Program Layout and Design

Structural Review

Exterior Elevation Notes: Emery Grover Building, Needham, MA

EXISTING
ROOF PLAN

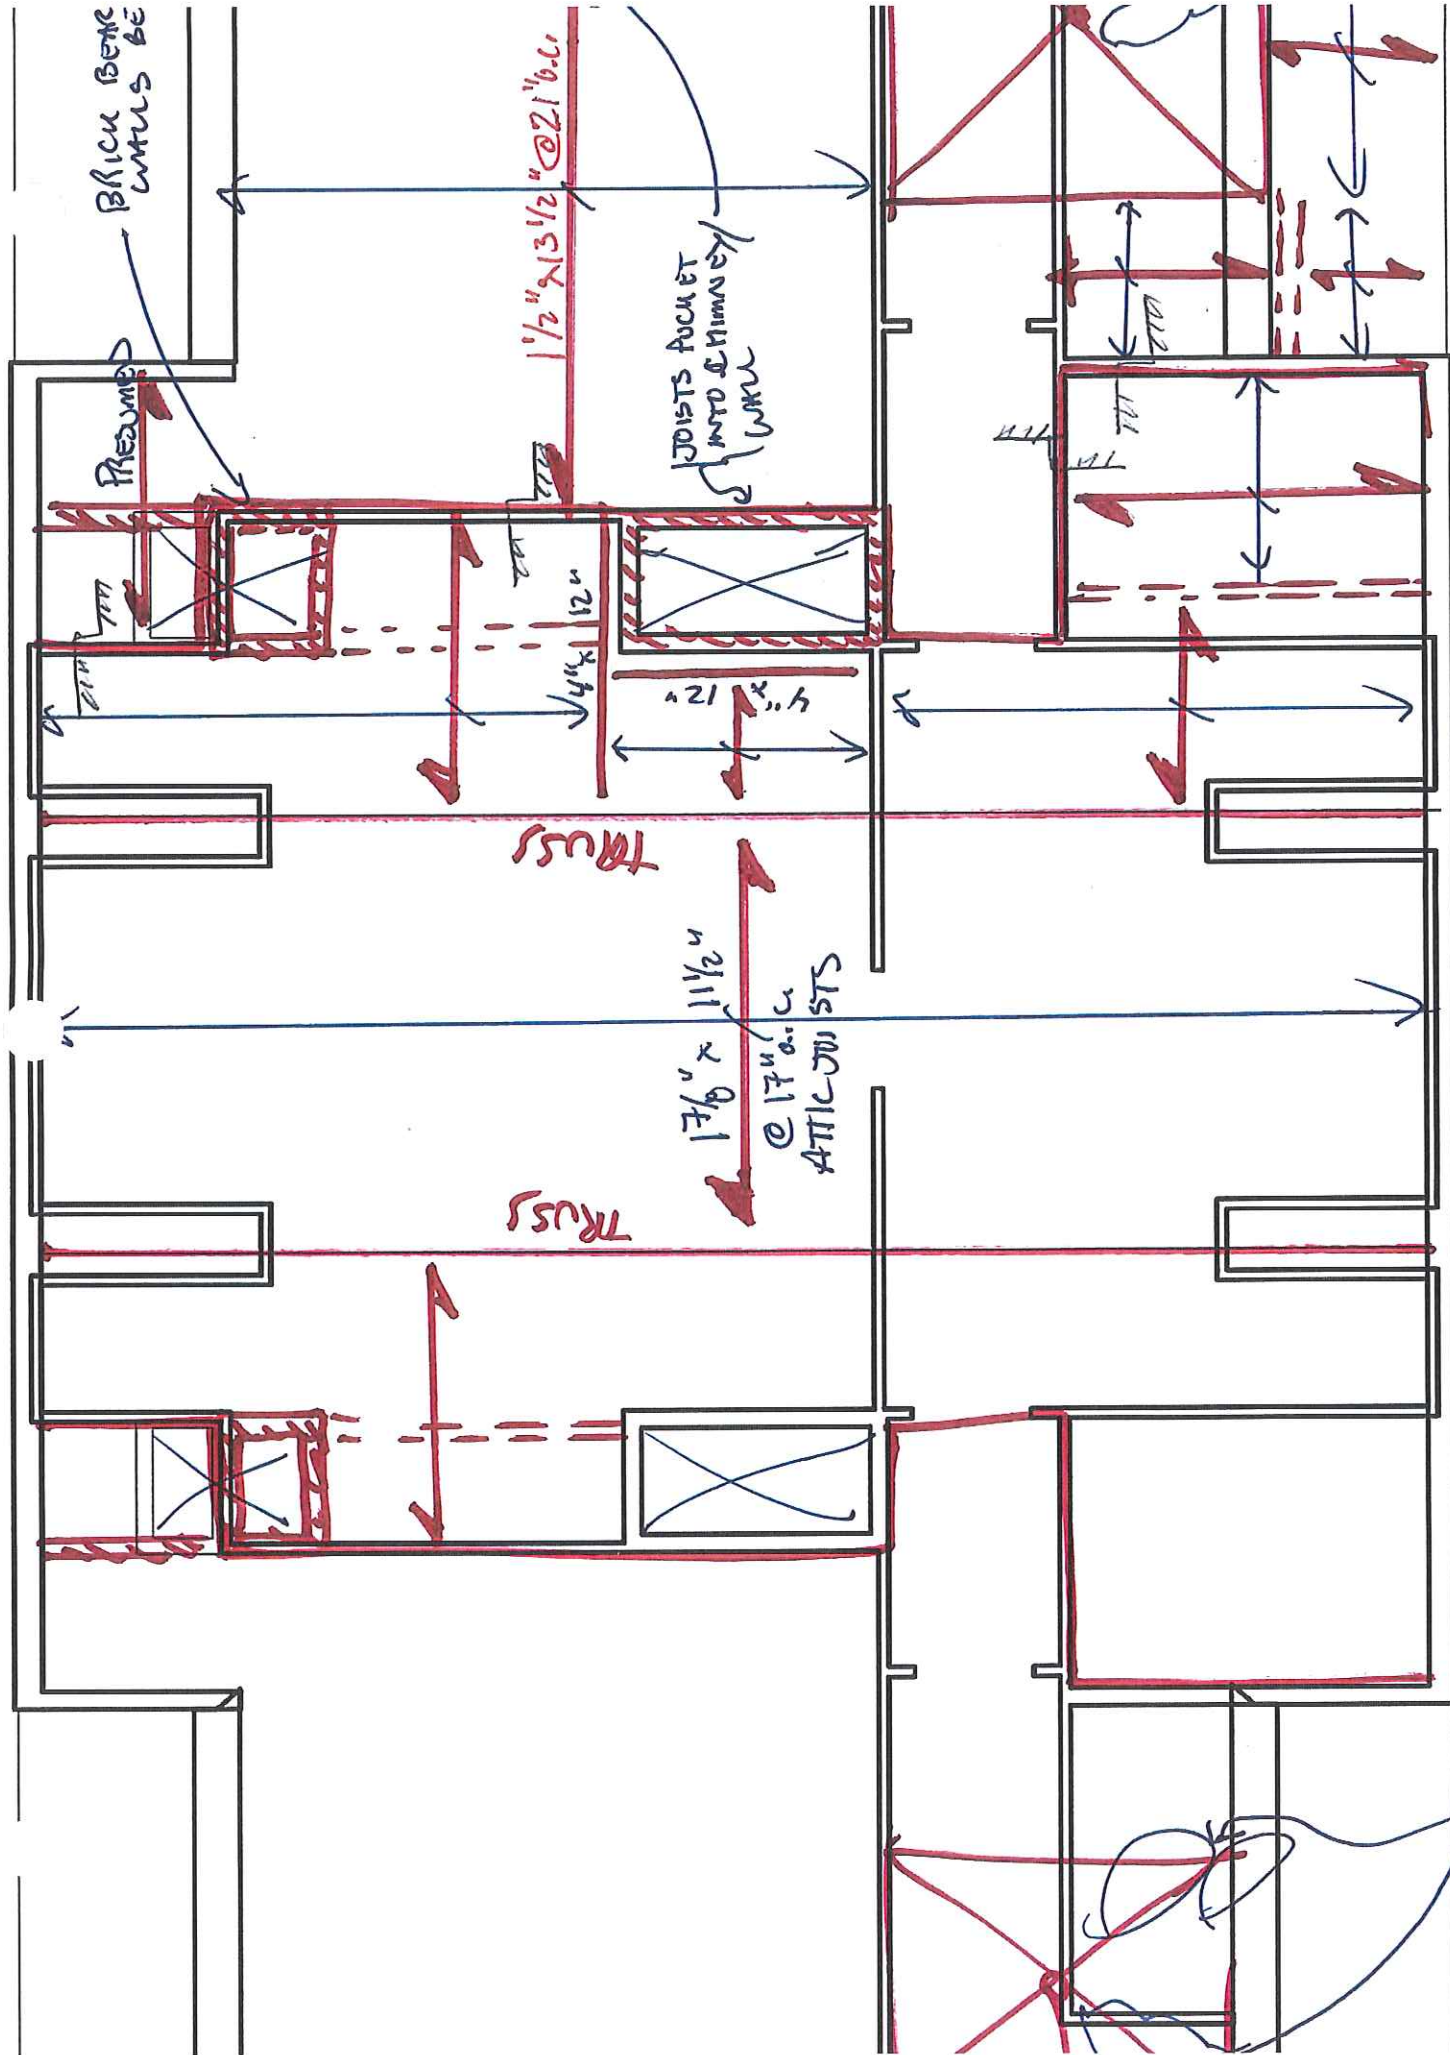
Not all attic framing was visible during Structures North's site visit. Snow guards were observed on the east and west sides of the building. It is assumed that the guards were not a part of original construction, and it is unknown whether the roof was evaluated or is capable of supporting the additional snow loads caused by snow guards. **The roof might need a full evaluation, and if found to be undersized, reinforcing and/or additional columns installed.**

EXISTING
ATTIC PLAN

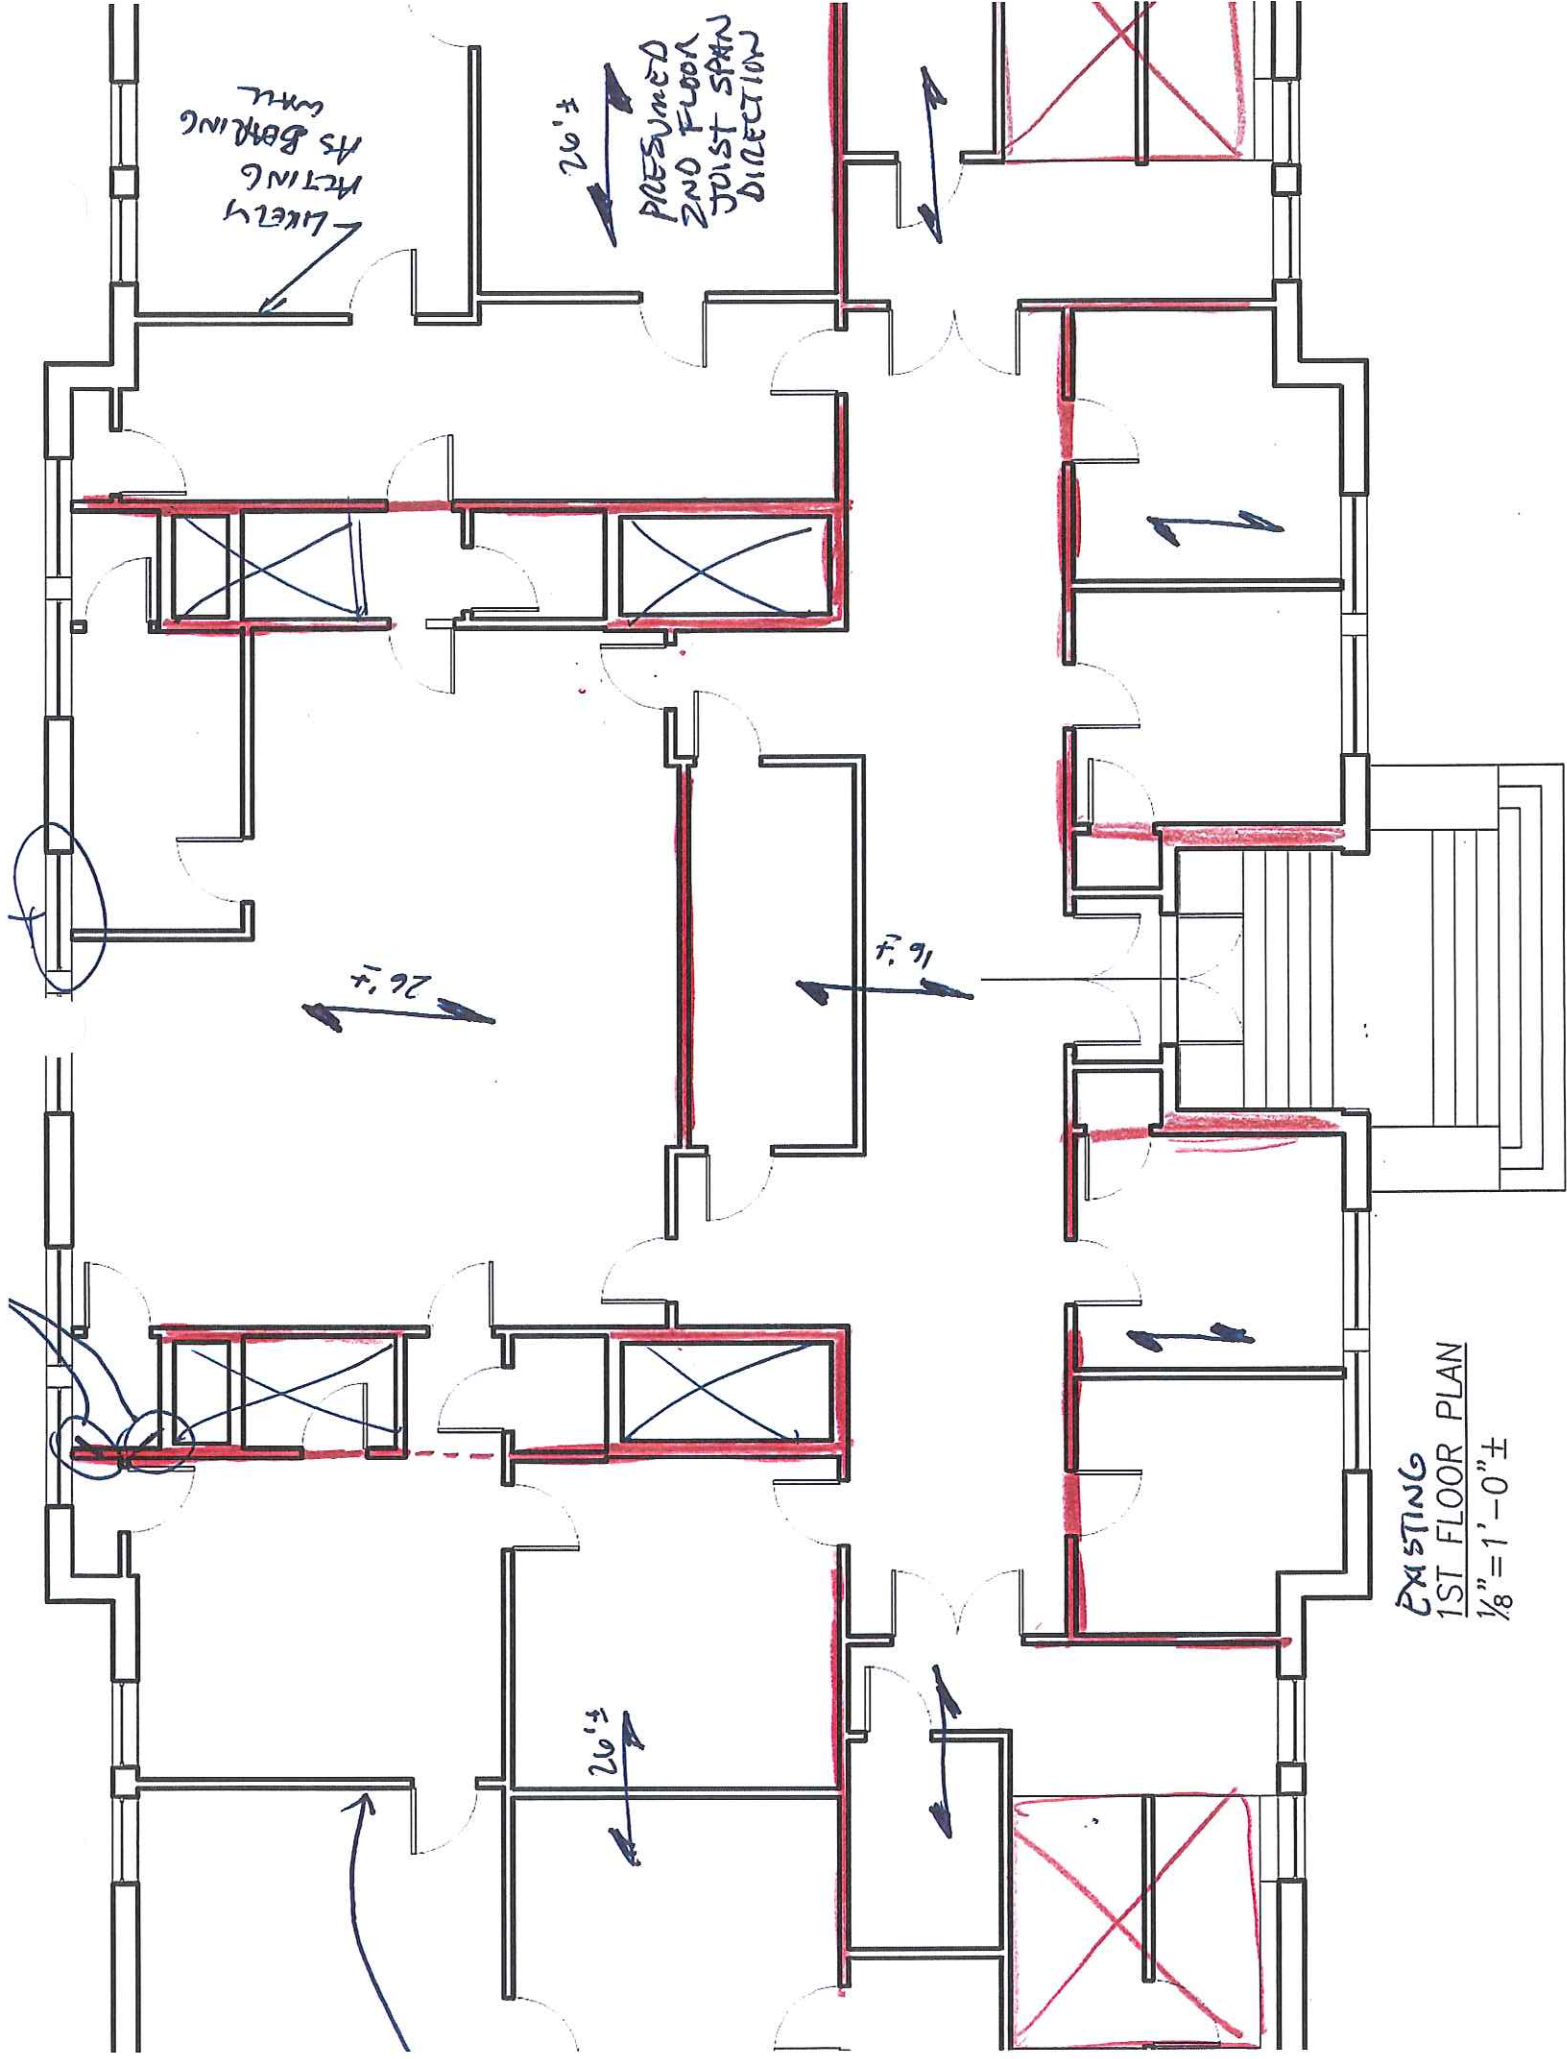
STAGE
BEAM ABOVE

(INTERIOR)
PRESUMED 2ND
FLOOR BEARING
WALLS FOR
ATTIC FRAMING

DROP IN CUG, UNKNOWN
IF MECH/ELECT/STRUCTURAL

SEE ATTIC PLAN FOR PRESUMED
ATTIC FRAMING

EXISTING
2ND FLOOR PLAN
 $\frac{1}{8}'' = 1' - 0'' \pm$

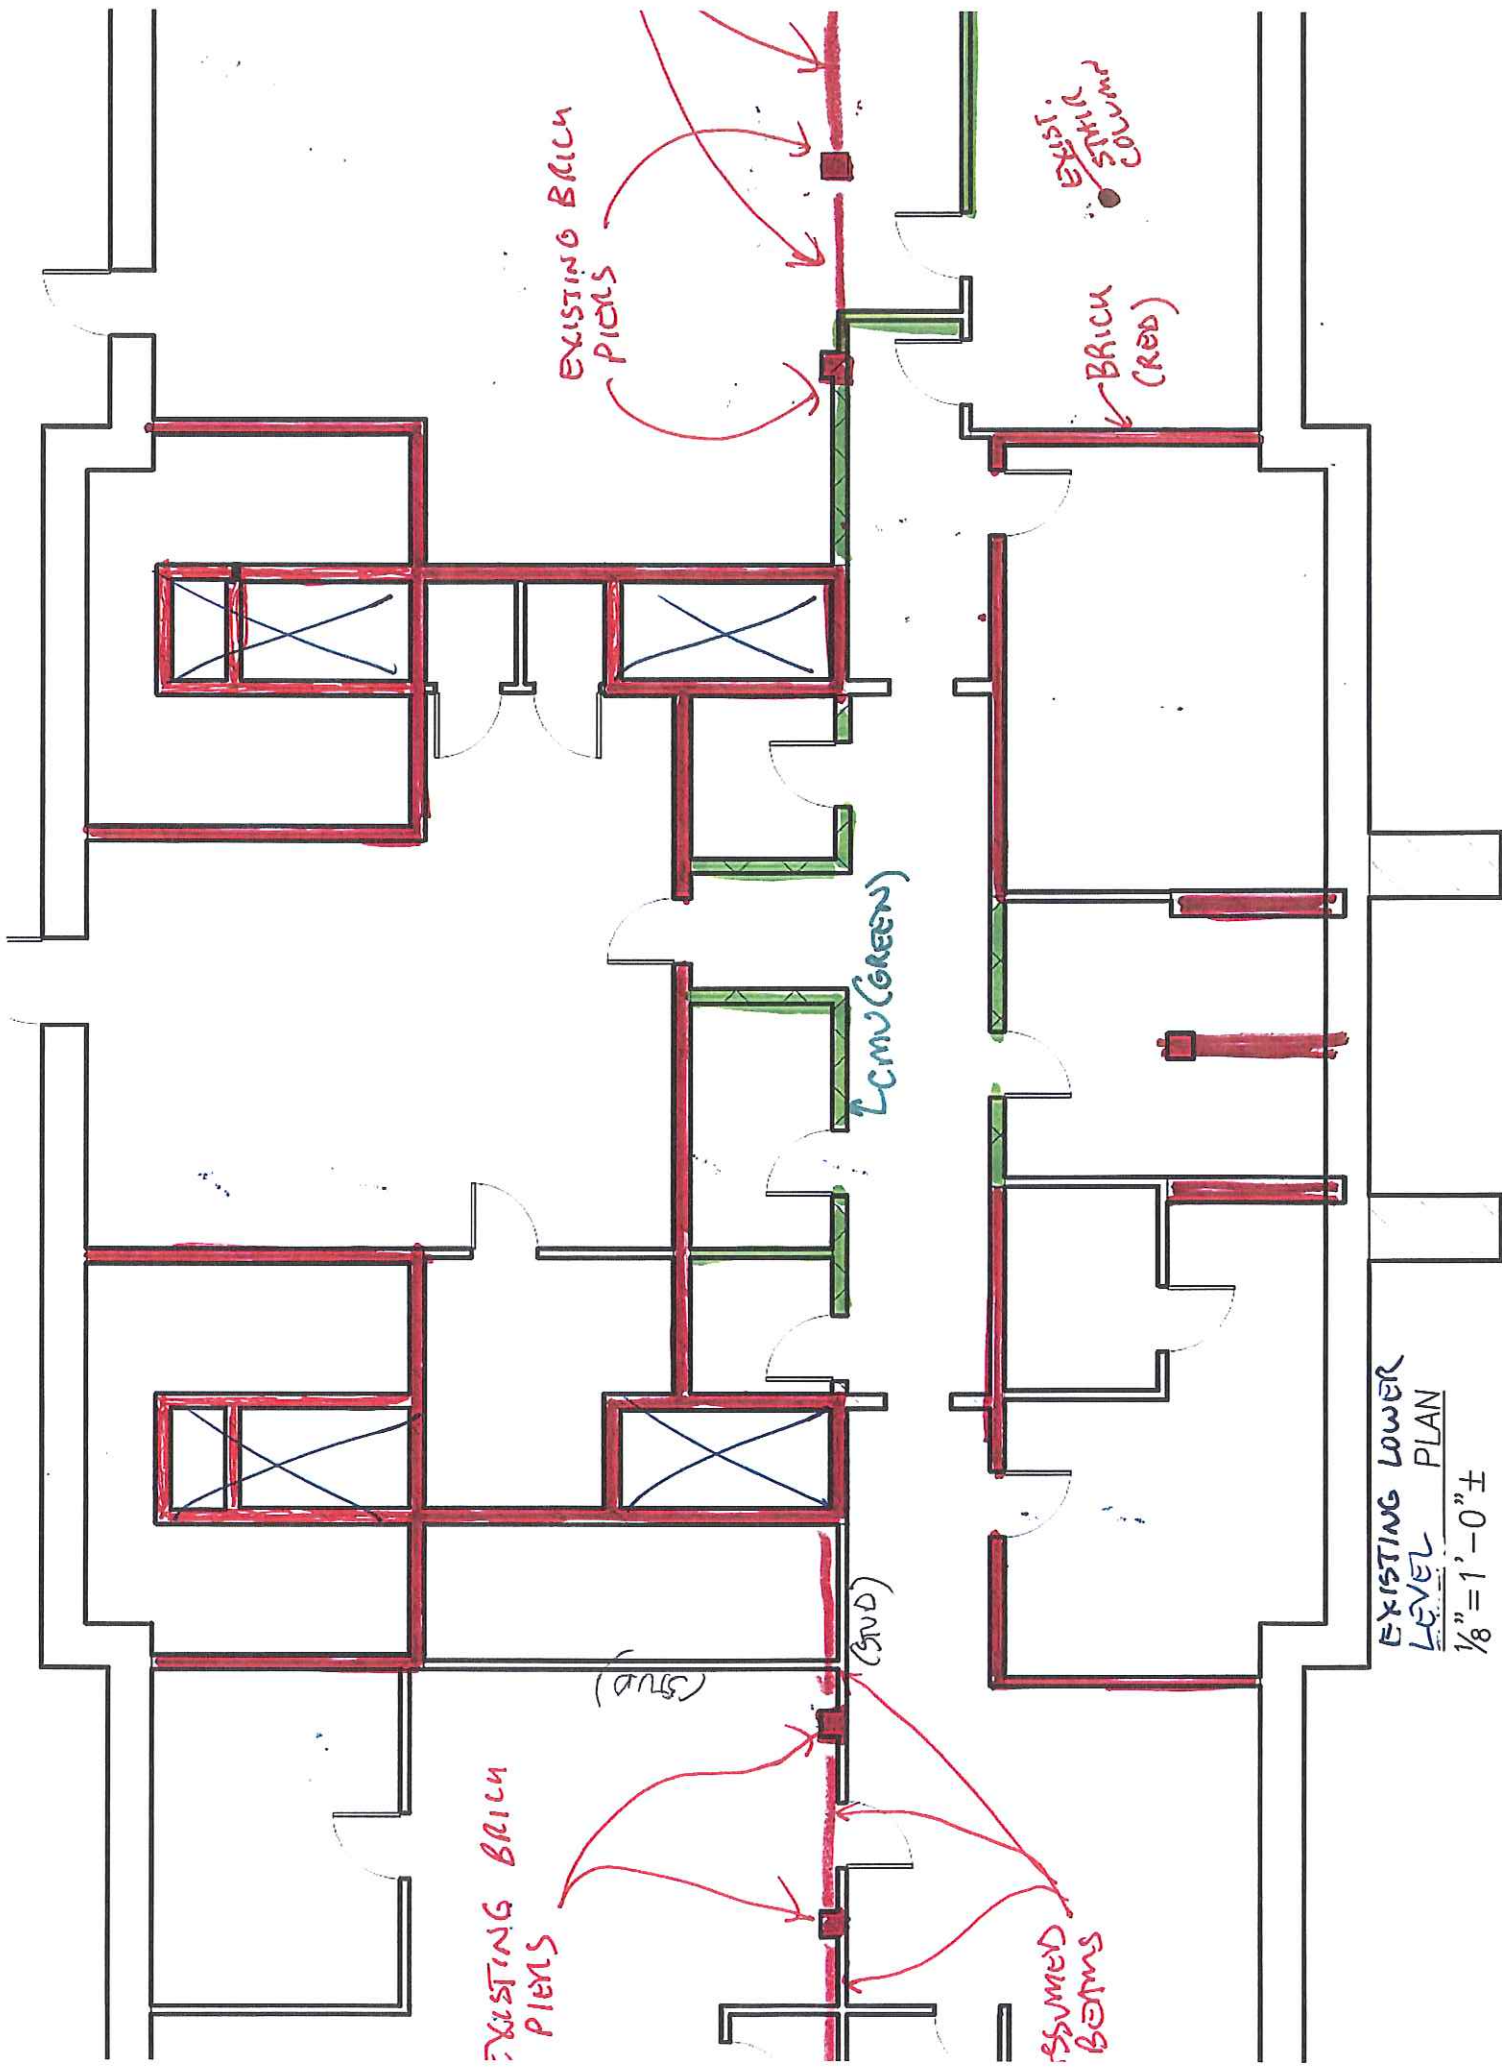
LIKELY
ACTING
AS BEARING
WALL

26'±
PRESUMED
2ND FLOOR
JOIST SPAN
DIRECTION
